To: RMA Hearings Panel Commissioners

From: Hayley Thomas, Project Planner

Subject: Section 42A Hearing Report on Proposed Plan Change 13 - Uplifting Deferred

Zones

Appendix S2 - Cambridge North Structure Plan and Design Guidelines

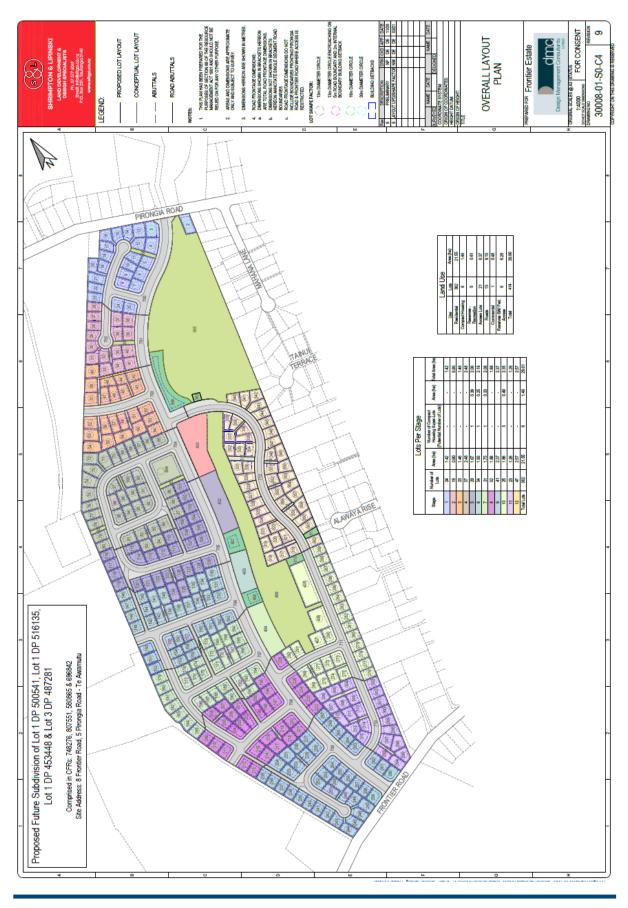
[13/5, 13/6, 13/7, 13/8]

- S2.6.2 The intention is that the stages do not necessarily have to follow a strict sequence or order. For that reason they have not been numbered but rather they have a colour description refer to Figure 1 below. In order for an area to be released for development a Development Agreement will need to be entered into with Council and the land rezoned through a Council resolution (as per the provisions of the Proposed Waipa District Plan). [13/2]

- S2.6.3 In order for an area to be re-zoned and released for residential development, a Development Agreement will need to be entered into with Council and the land rezoned through a Council resolution (as per the provisions of the Proposed Waipa District Plan). The Development Agreement will be entered into by Council and the developer which clearly outlines the nature and timing of any necessary infrastructure, and how this infrastructure is to be developed and funded. The agreement will need to be clear as to whether the infrastructure is implemented prior to development or part of the development process. Funding and timing of all infrastructure required to service further development within Cambridge North will be specified in the Developers Agreement. [13/2] The individual growth area and development capacity of each stage is outlined in the Table that follows Figure 1, along with the infrastructure required to service that growth area. The stormwater infrastructure described represents the requirements of a comprehensive, technically robust stormwater management solution for CNRA. The solution is not necessarily the only technically viable solution and it is possible that alternative solutions that achieve the required levels of service described in the technical assessments and investigations undertaken to support the updated Structure Plan are available.

Appendix S23 - Cambridge C4 Growth Cell Structure Plan (NEW)

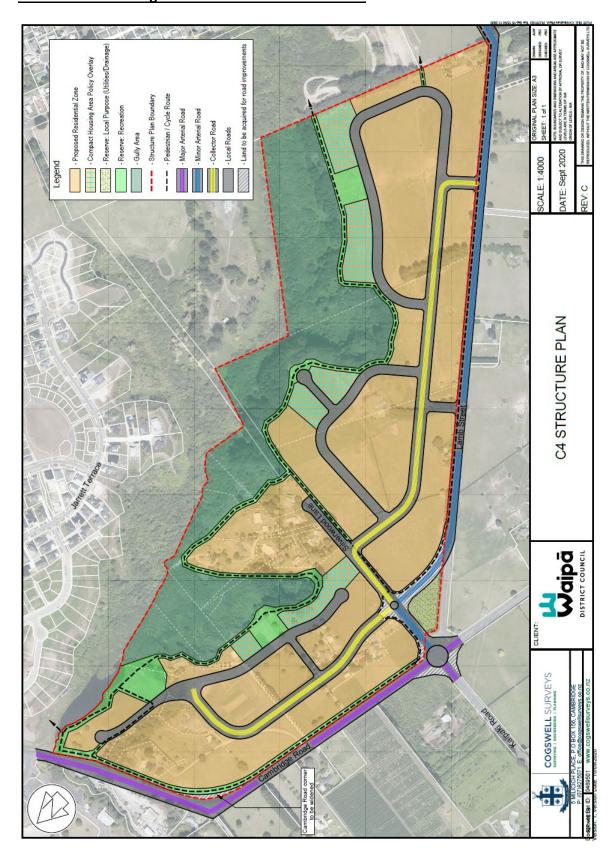
19/7	Kotare Properties Ltd	Appendix S23.4.4	Support In Part	This section of the Structure Plan identifies that the gully reserve will anchor two neighbourhood reserves. The Structure Plan shows three reserves, two north of Silverwood Lane and one south. This paragraph should be updated to reflect the desired outcome that Council wants to achieve in terms of the number of reserves i.e. two or three. If it is also only two then the Structure Plan should be amended to reflect	Update the language in S23.4.4, and if necessary amend the Structure Plan, to reflect what Council wants to achieve in terms number and location of reserves.	Reject Refer to paragraphs 5.5.11 to 5.5.16 below.

- (a) Amendment in \$23.3.2 to a structure plan rather than the proposed structure plan;
 - (b) Amendment in S23.3.5 to remove reference to swales being the preferred stormwater treatment technique;

- (c) Update the text in S23.4.4 to reflect the number of reserves and their locations sought by the Council;
 - (d) Amendment of S23.5.3 so that the structure plan is referred to as a conceptual layout not a preferred layout; and

- (e) Amendment of S23.6.3 to refer to three stormwater collections points, not two as notified.
- 5.5.12. Submission 28/1 also seeks the amendment of the endorsed C4 Structure Plan to provide a second entrance onto Cambridge Road.

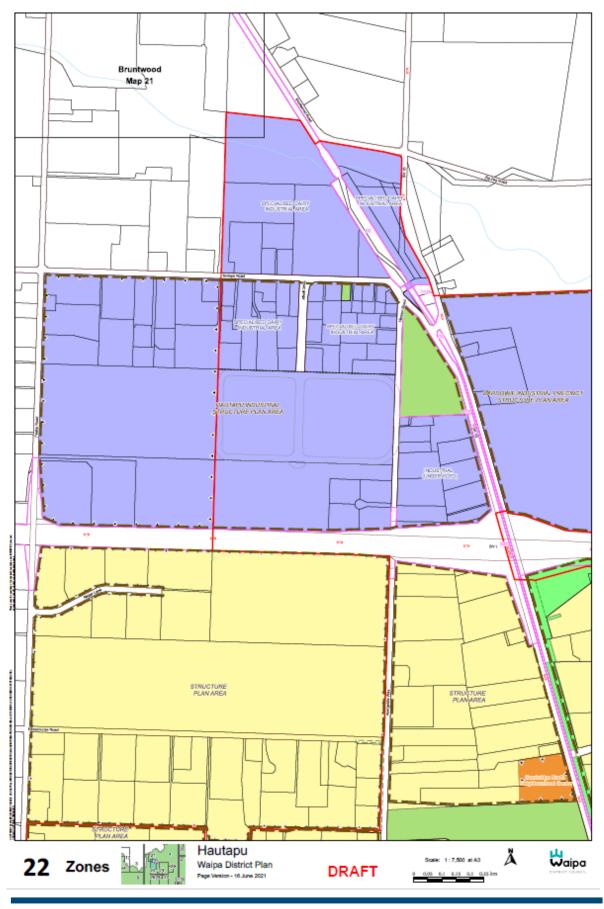
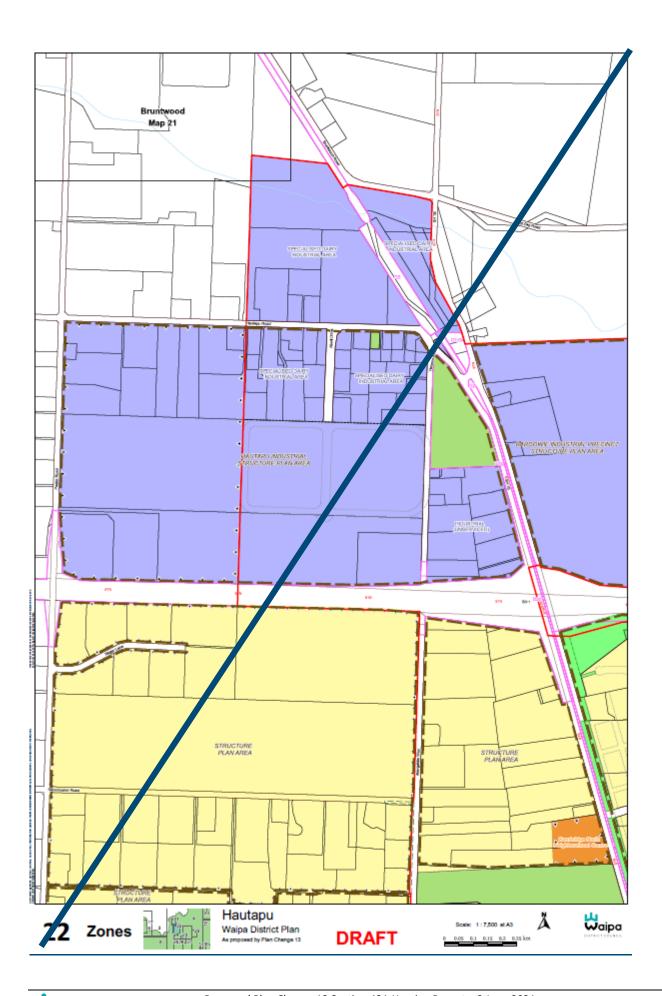
- 5.2.10. Submission 19/3 seeks the amendment of the urban limits on the Planning Maps to include, as a consequential amendment, the uplifted growth cell areas. The Urban Limits has been included in the District Plan to define the urban areas identified through the Regional Policy Statement and Council's Growth Strategy. To ensure future development within the uplifted growth cells can align with the relevant objectives and policies with Section 1 of the District Plan, and to reflect the amendments made as a result of this Plan Change, it is considered appropriate to amend the location of the urban limit to include the uplifted growth cells. Council staff support this amendment and recommend the Urban Limits on the Planning Maps is updated to include the uplifted deferred zone areas.

[19/3, 13/6, 13/8]

- Accept Submission 19/3;
- Accept in Part Submissions 7/1, 7/2, 16/1, FS6/12, 16/2, FS6/13;
- Reject Submissions 2/1, 15/1, FS1/1, FS5/1; and
- Amend the Planning Maps to include the uplifted deferred zones within the Urban Limits.

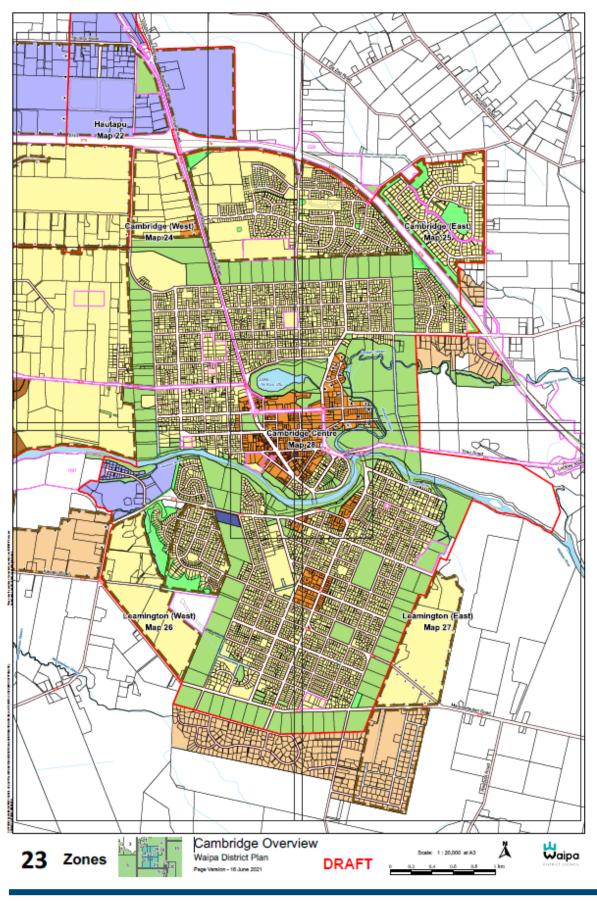
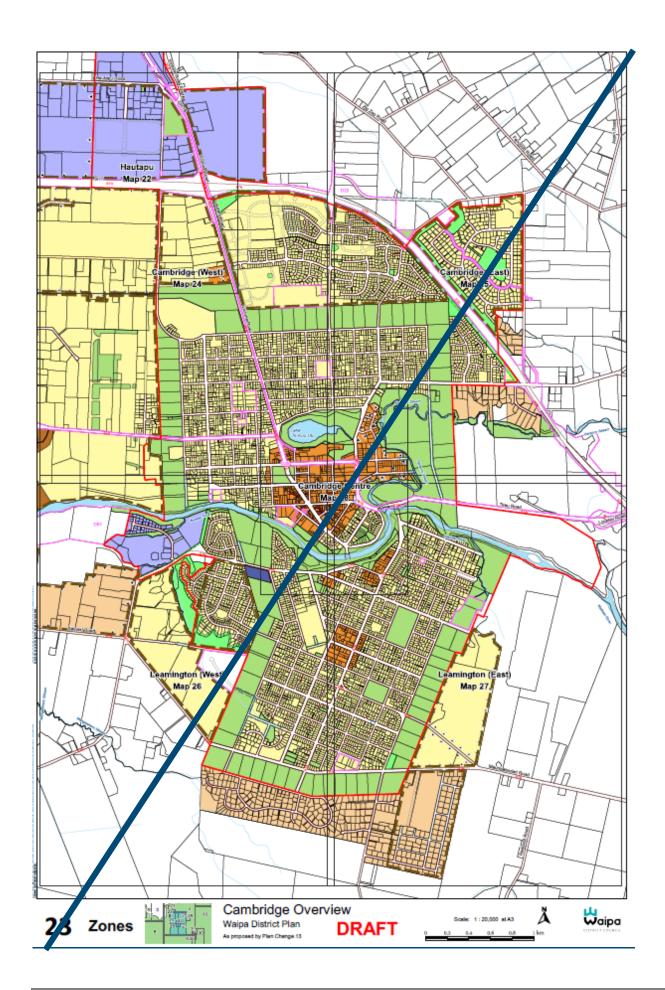
[19/3, 13/6, 13/8]

[19/3, 13/6, 13/8]

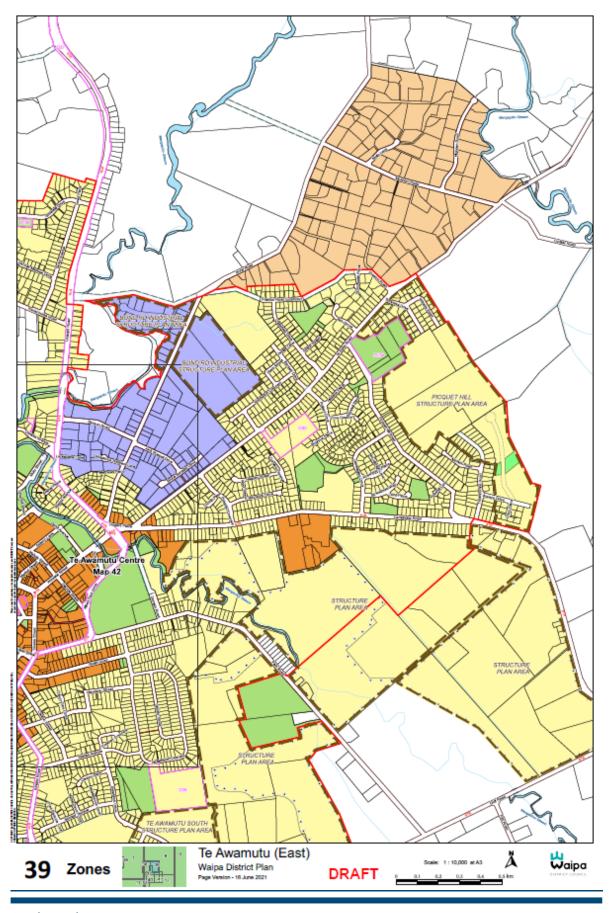
[19/3, 30/5]
